**TRANSMITTAL OF THE ADDENDUM TO THE CERTIFICATION DESIGN LETTER
FOR AREA 2, PHASE II - SUBAREAS 1, 2, AND 4 AND THE PROJECT SPECIFIC
PLAN FOR AREA 2, PHASE II - SUBAREAS 1, 2, AND 4 CERTIFICATION
SAMPLING**

**ADDENDUM TO THE
CERTIFICATION DESIGN LETTER AND
PROJECT SPECIFIC PLAN FOR
AREA 2, PHASE II - SUBAREAS 1, 2, AND 4
CERTIFICATION SAMPLING**

**FERNALD CLOSURE PROJECT
FERNALD, OHIO**

**20450-RP-0005
20450-PSP-0004
REVISION 0
ADDENDUM**

FIGURE 1. AREA 2, PHASE II - SUBAREA 4 HAUL ROAD LOCATION MAP

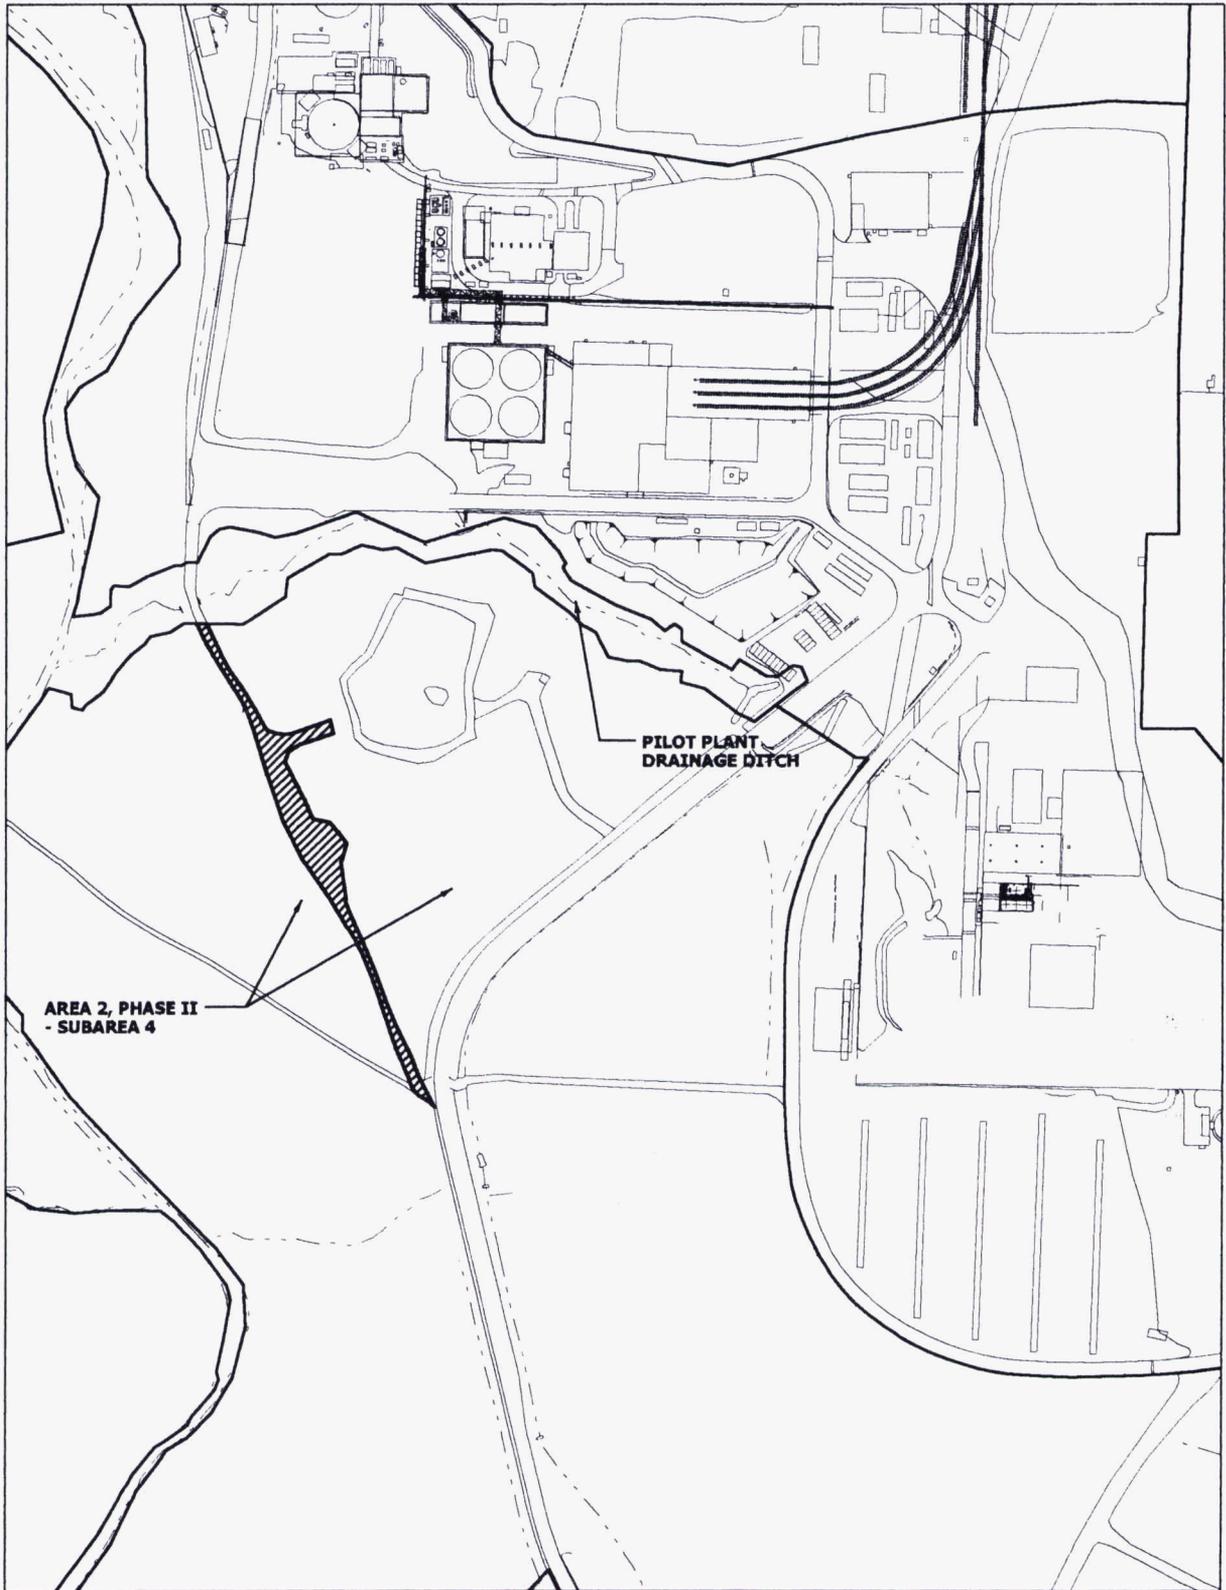
This letter and enclosure are being submitted for your review as a draft addendum to the Certification Design Letter (CDL) for Area 2, Phase II - Subarea 1, 2, and 4 (Document 20450-RP-0005) and the Project Specific Plan (PSP) for Certification Sampling of Area 2, Phase II - Subarea 1, 2, and 4 (Document 20450-PSP-0004). The scope of this addendum is the previously certified and restored road, an area of approximately 0.51 acres that begins at the Pilot Plant Drainage Ditch to the north and terminates with the Area 2, Phase II - Subarea 3 Impacted Material Haul Road to the south running through the middle of Area 2, Phase II - Subarea 4 (see Figure 1 of this addendum).

<u>Revision</u>	<u>Date</u>	<u>Description of Revision</u>
0	12-16-03	Initial controlled issuance.
Addendum 1	5-30-06	Scope of this addendum is to recertify the previously certified and restored road, an 0.51-acre area from north of the Pilot Plant Drainage Ditch ending with the A2PII Impacted Material Haul Road to the south running through the middle of A2PII - Subarea 4.

FIGURE 2. AREA 2, PHASE II - SUBAREA 4 HAUL ROAD CU, SUB-CU, AND SAMPLE LOCATION MAP

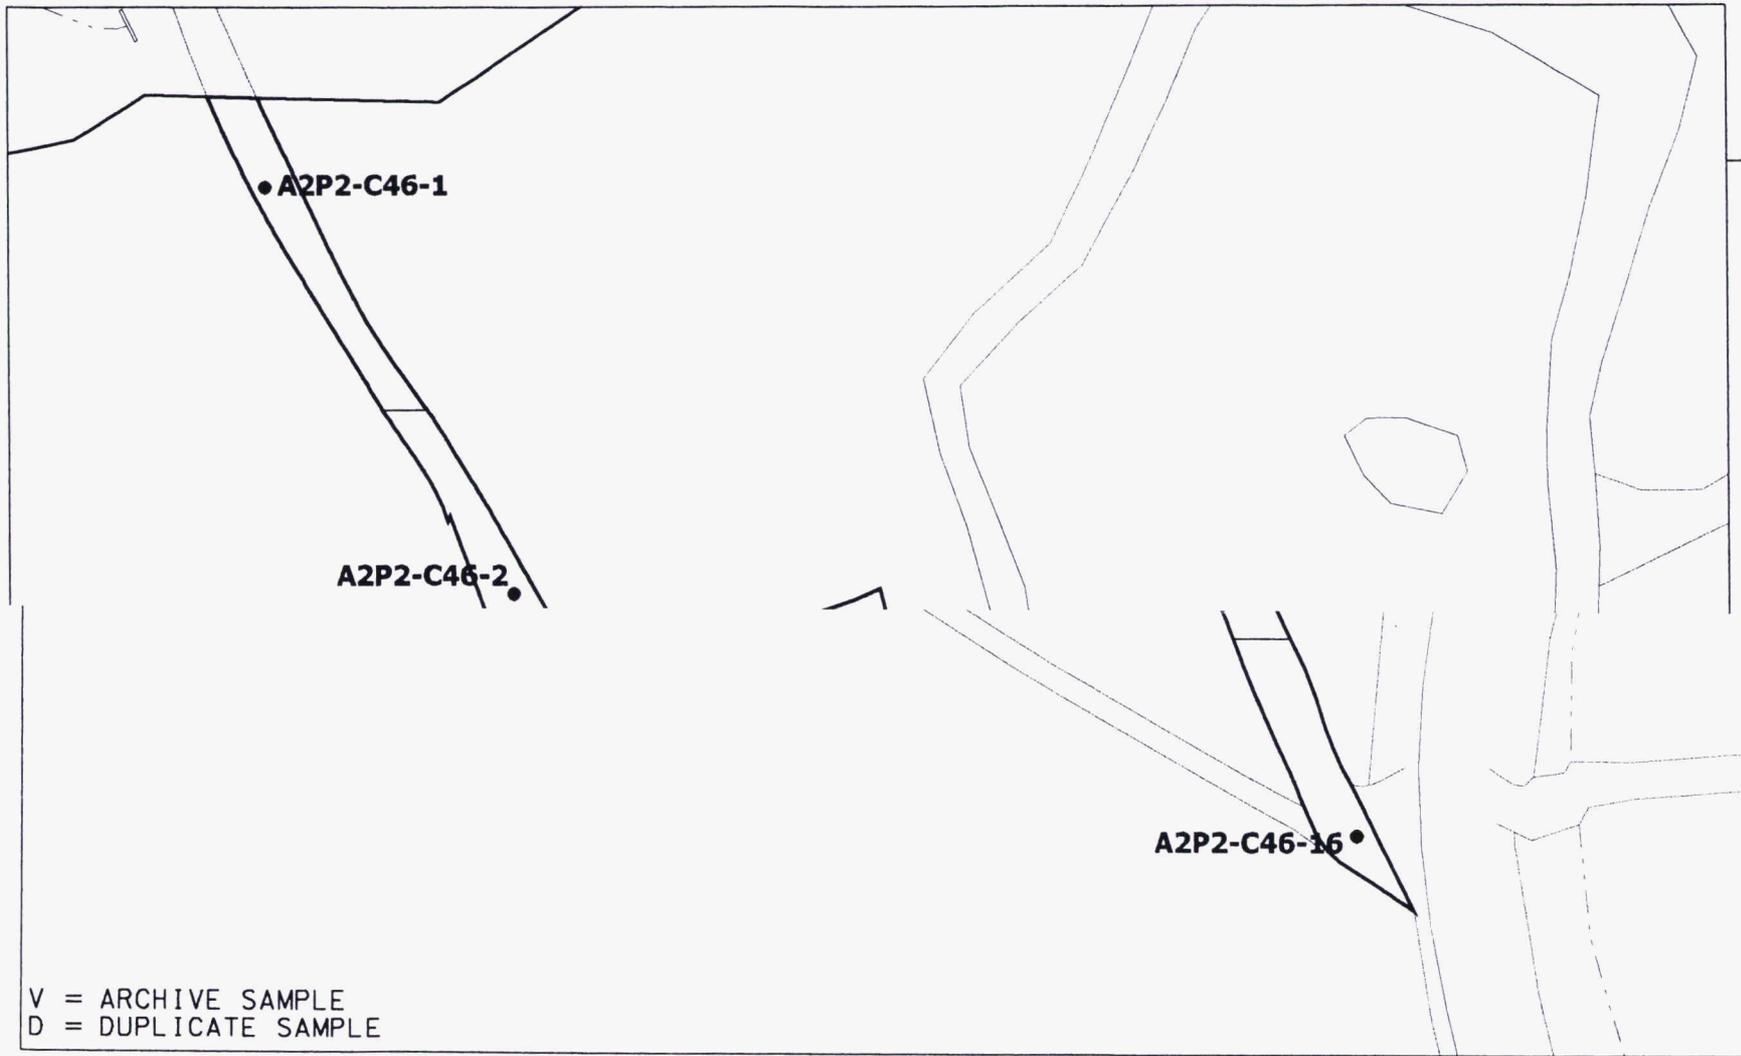
As with other certification units (CUs) in Area 2, Phase II - Subareas 1, 2, and 4, the certification design follows the general approach outlined in Section 3.4 of the Sitewide Excavation Plan. The scope of this addendum consists of one Group 1 CU for the footprint of the haul road. This CU design is shown in Figure 2 of this addendum. The overall certification design, sampling, analysis, and validation necessary to demonstrate that soil in this area has met the final remediation levels for all area-specific constituents of concern (ASCOCs) is presented in the CDL and Certification PSP. Specific information for the CU design of the haul road is contained in this addendum and is similar in design to the certification CU previously sampled in this location. The sub-CUs and sample locations presented in Figure 2 and Attachment 1 include the entire Area 2, Phase II - Subarea 4 haul road. The Sampling and Analytical Requirements as well as the Target Analyte List are in Attachment 2 of this addendum. Total uranium, thorium-228, thorium-232, radium-226, and radium-228 (the primary site ASCOCs) will be retained in this CU (see Attachment 2).
